Appl. No. 09/838,004  
Amdt. dated November 6, 2003  
Reply to Office Action of November 20, 2002

**REMARKS/ARGUMENTS**

Figure 2

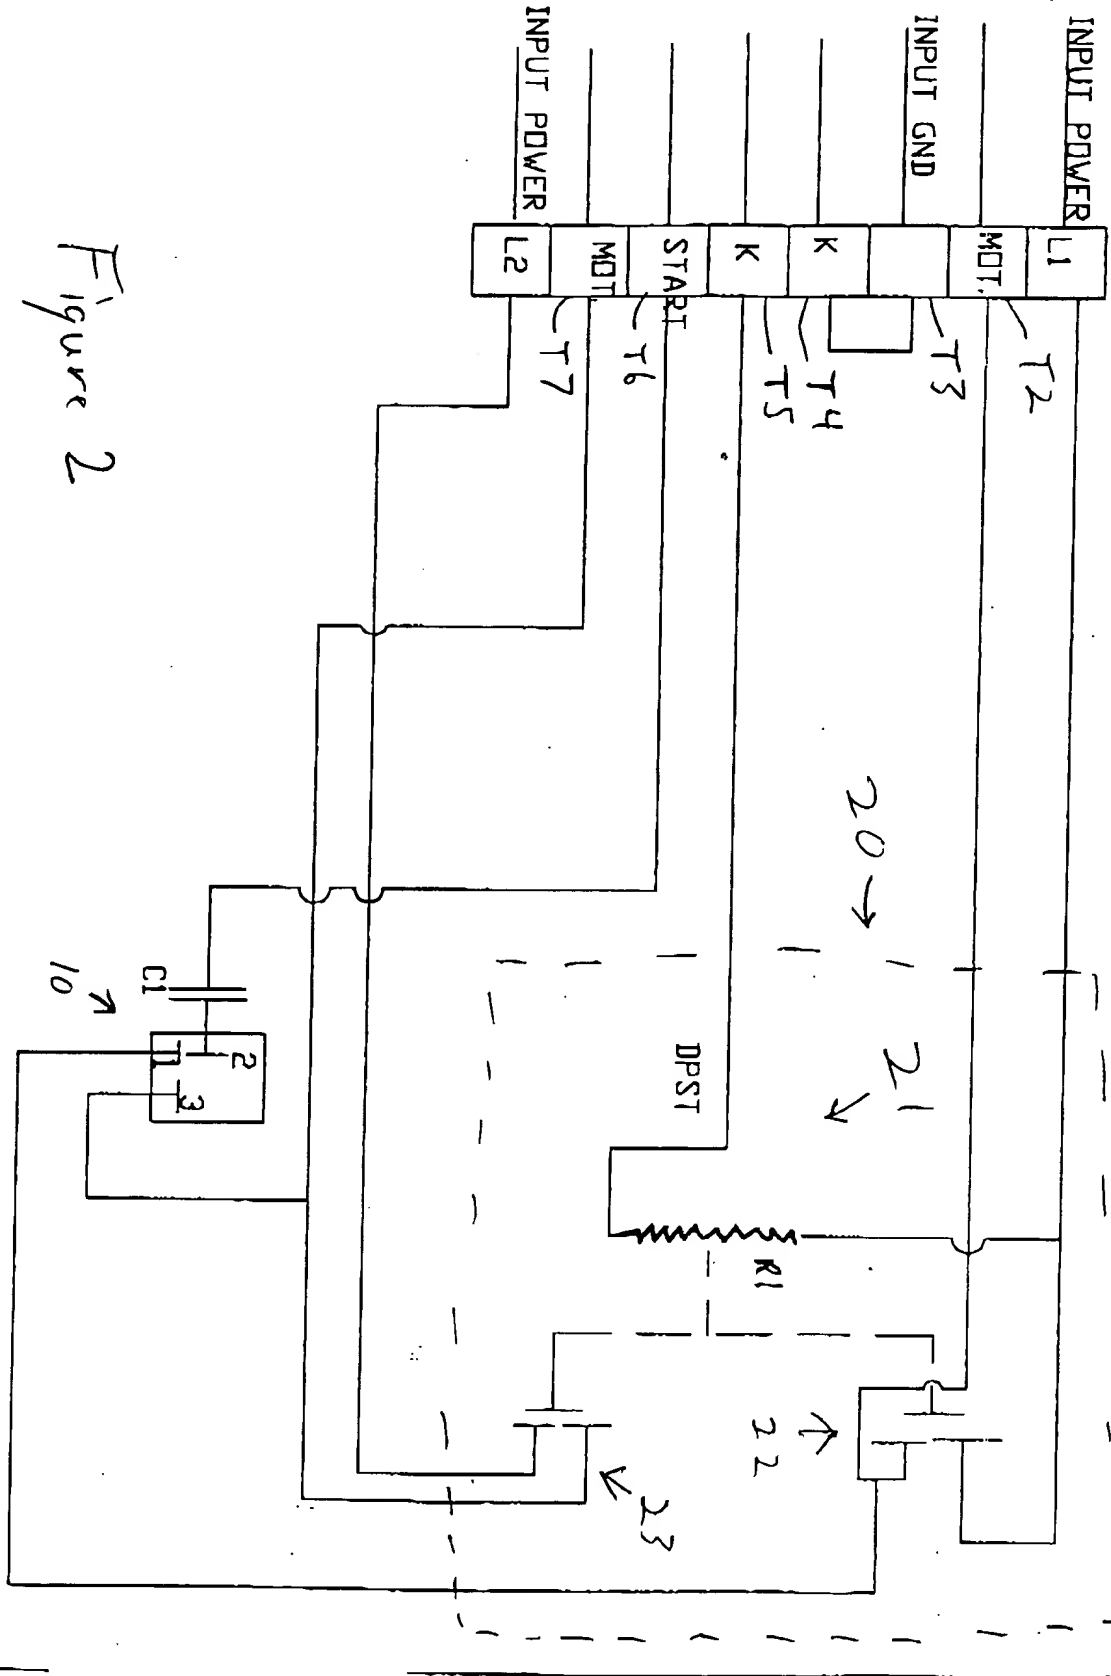
The Examiner objected to the drawings for not showing every feature of the invention specified in the claims. Accordingly, Applicants submit herewith a proposed new Figure 2 that illustrates a resistor coupled to at least one transistor switch. It is respectfully submitted that no new matter has been added.
